**Re: Lot 18 DP 270644, Greystanes Southern Employment Land (Boral Land)
Section 96 Application SSD_6801**

We provide this letter relating to a proposed Section 96 application to the Greystanes Southern Quarry West project approved under SSD_6801. Specifically this letter covers the civil engineering aspects of the amendment.

The Section 96 Application is for an amendment to the approved layout defined in SSD_6801, and to the previous two Section 96 Applications dated 29 April 2016 and 20 September 2016. The main component of the current amendment is for an adjustment to the approved masterplan lot layout in Precinct B.

SITE MASTERPLAN

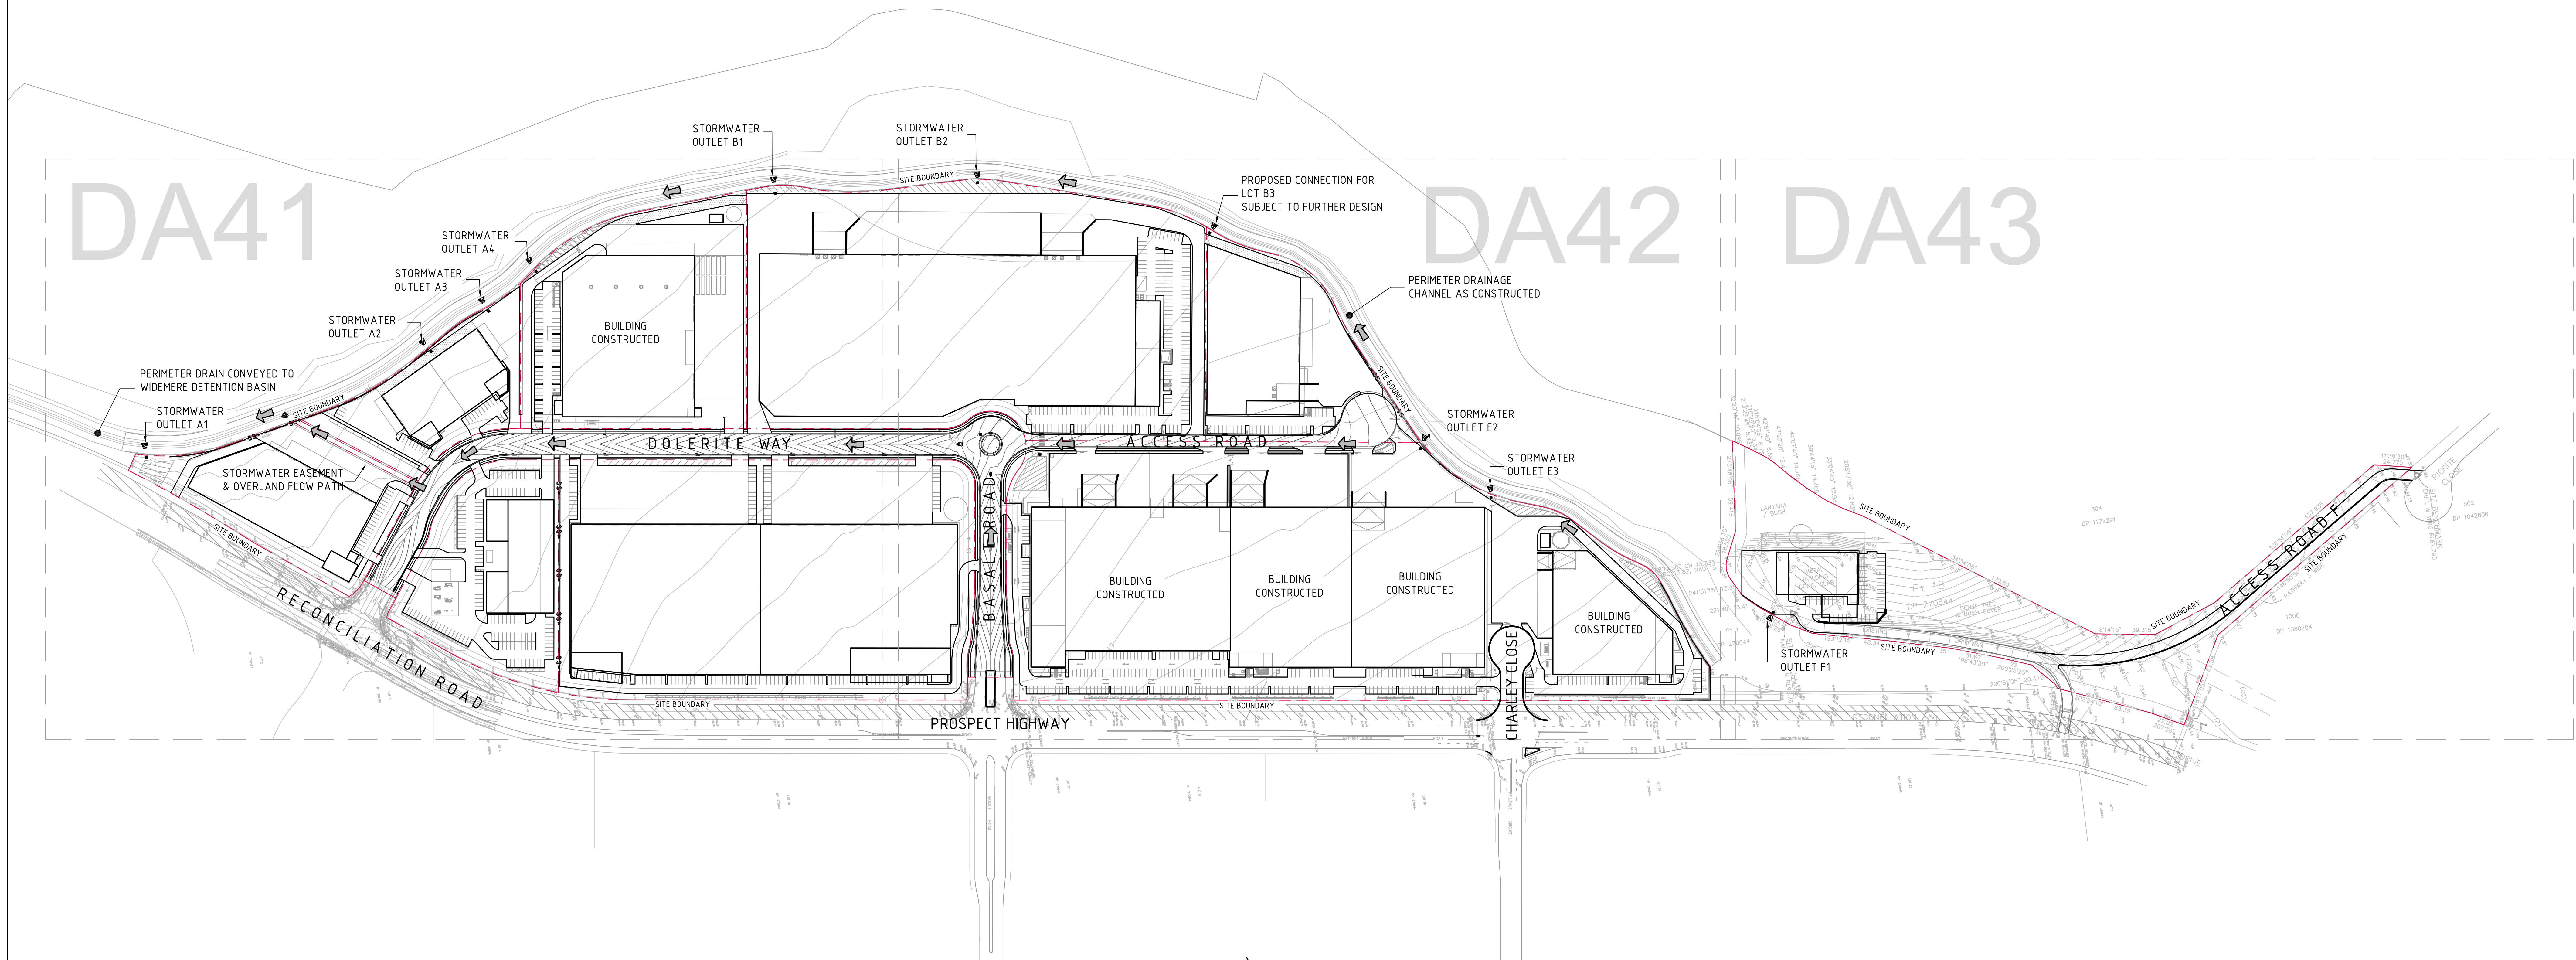
The development layout differs from the previous submission in that the arrangement of the development lots on the northern side of Dolorite Close within Precinct B have been adjusted.

Warehouse B1 is now constructed and the adjustments to the masterplan relate to Warehouse B2 and Warehouse B3. The lot layouts to the east and south of the estate road

are generally consistent with the previous application. Some minor changes to car park arrangement to the north of Warehouse B3 have also been made. The floor level of warehouse B1 remains consistent with the previous application however Warehouse B2 and B3 have been amended to suit access from Dolerite Close, to meet flood planning requirements and to achieve cut to fill of earthworks over the site. It is noted that the final building level will be subject to detail geotechnical and earthwork volume assessment and may vary +/-500mm from the nominated level.

STORMWATER MANAGEMENT/WATER QUALITY STRATEGY
SCALE 1:1000

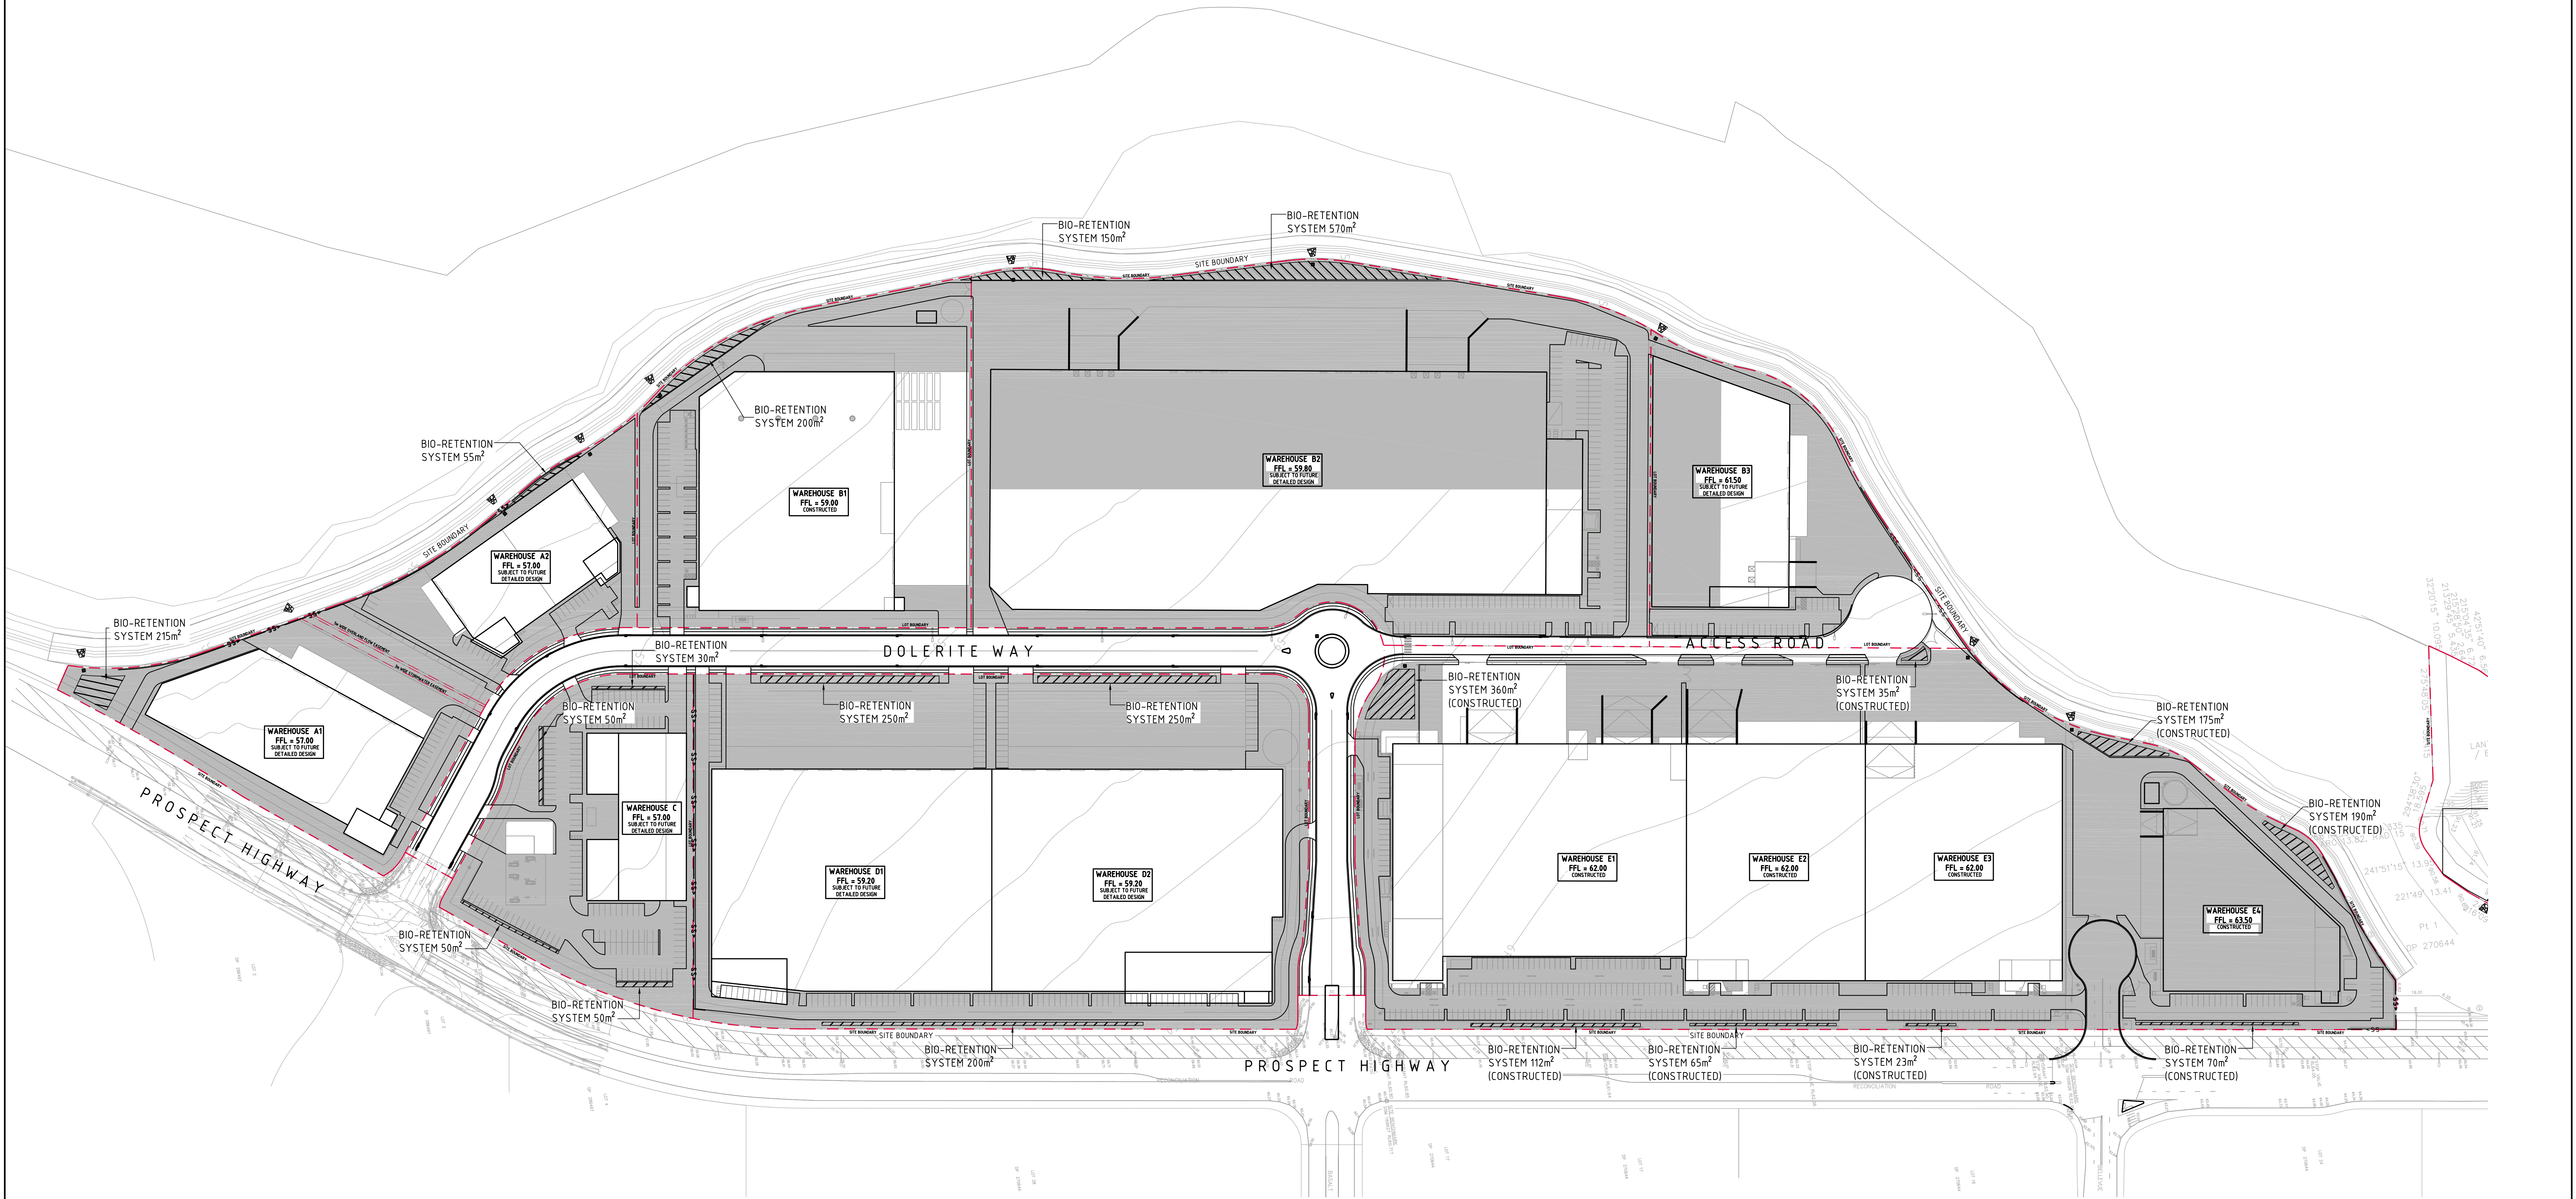
Minor adjustments to the locations of the bio-retentions within the site have been made. The basin to the north of Warehouse B2 & Warehouse B3 has been adjusted as a result of the carpark arrangement specified above. It can be confirmed that the minimum required 3000m² of bio retention, as defined in SSD_6801, has been provided.
